SB11050004 Adjustment plates on vehicles Citroen Jumper 2.2 / Peugeot Boxer 2.2 / Fiat Ducato 2.2

Drive kit:
KC07040108

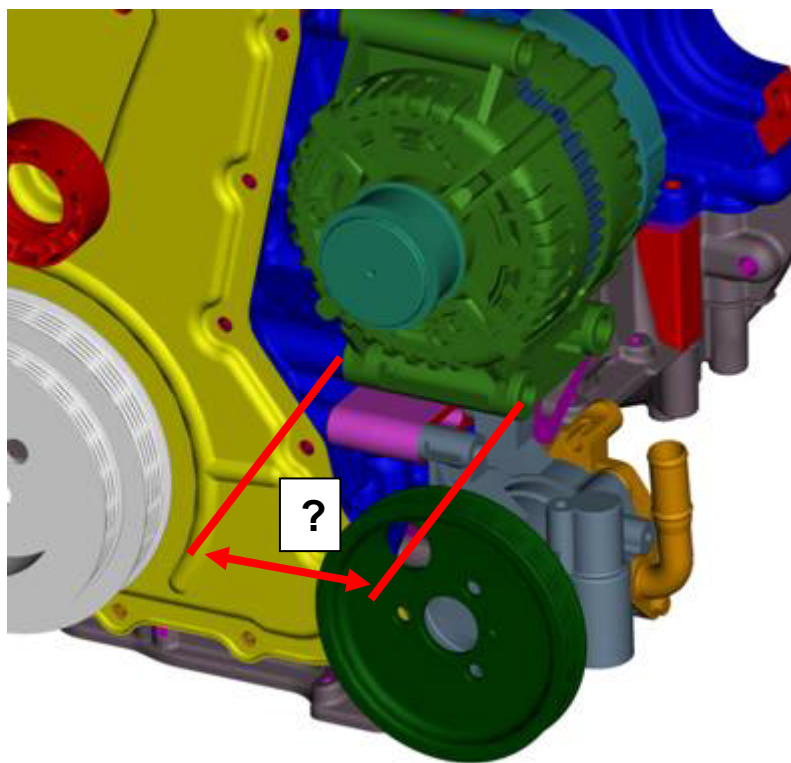
- Take indicated measure. **ONLY** if value is 97 ± 1 add the two 4 mm plates between steering pump and compressor bracket.
- Tomar la medida indicada. **UNICAMENTE** si el valor obtenido es 97 ± 1 entonces añadir las dos placas de 4 mm entre el alternador y el soporte del compresor.
